PCN – Process Change Notification

Change:	TI.19.2113
Date:	2016/11/01
Author	Bonnie Chen

Model#	Part Number	Changes
TI.19 2dBi 915MHz ISM Band Dipole Antenna	TI.19.2113	Amend Tolerance.

Illustration of Change
Old drawing

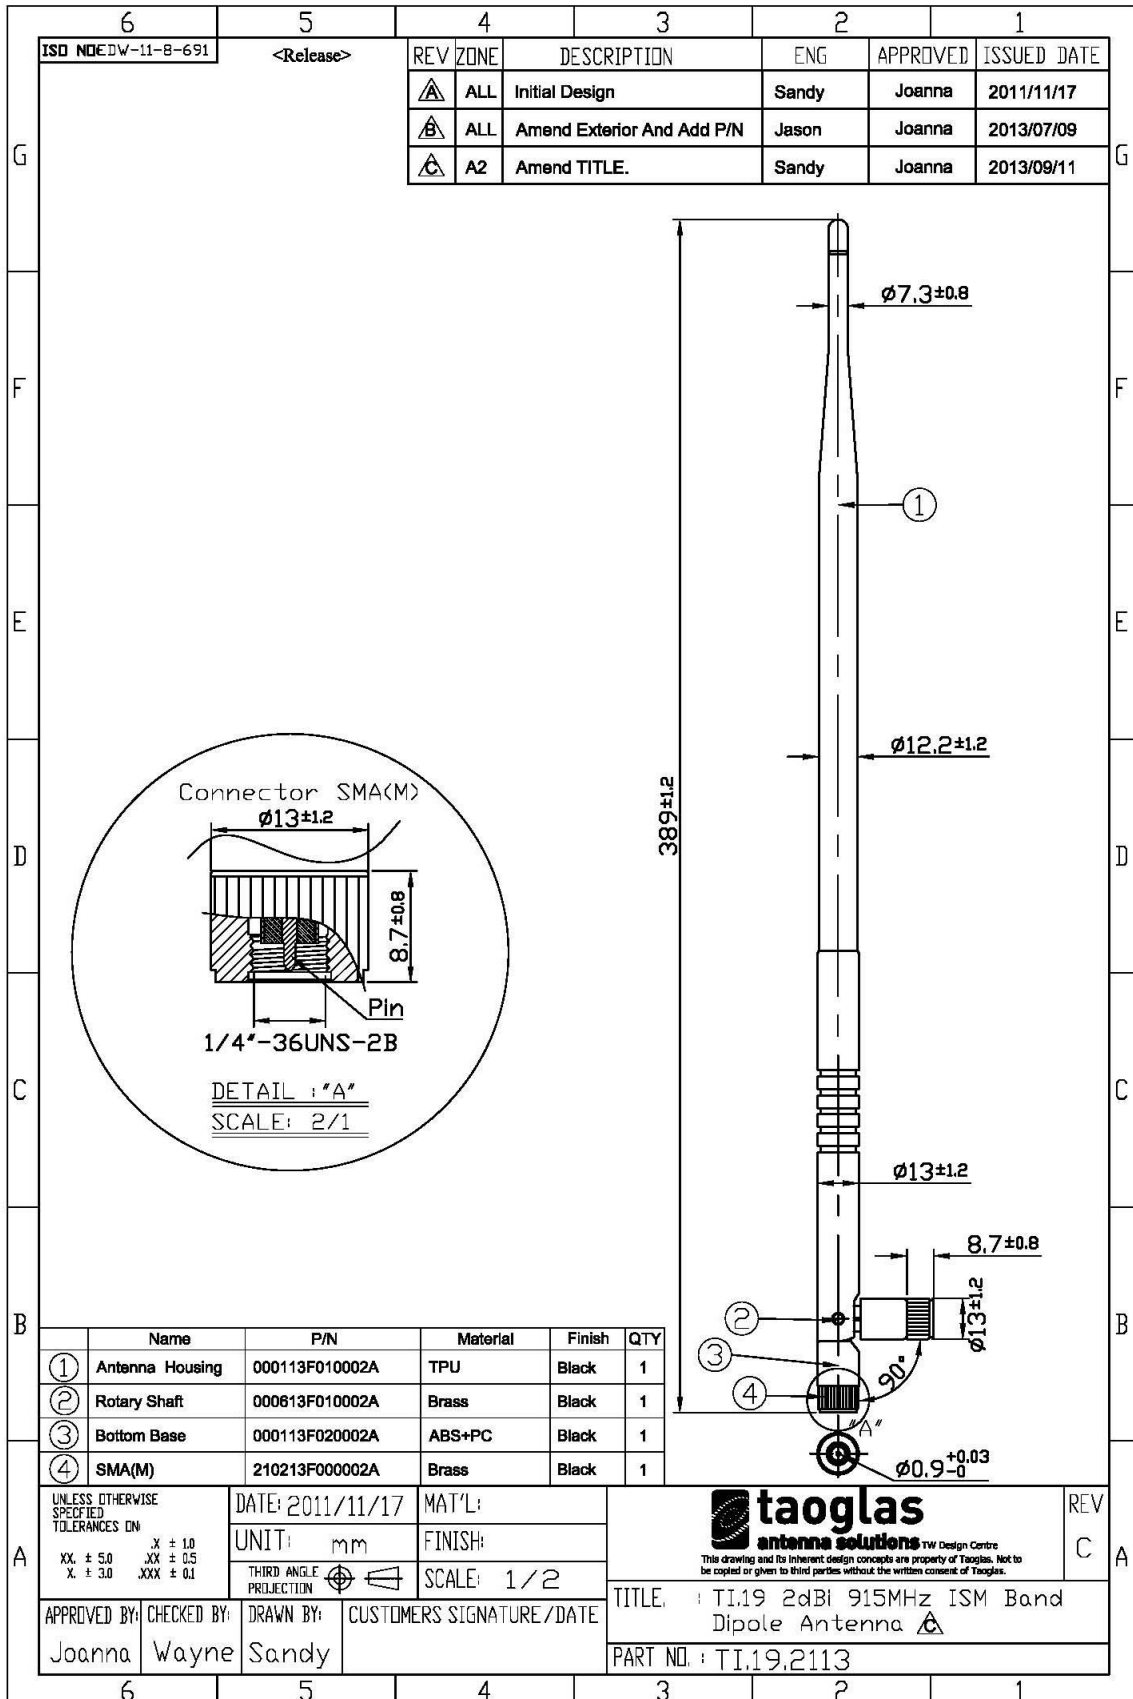
- Amend tolerance of antenna length from 389+/-1.2mm to 389+/-12mm, because of original drawing was typo in it, the actual sample tolerance is +/-12mm.
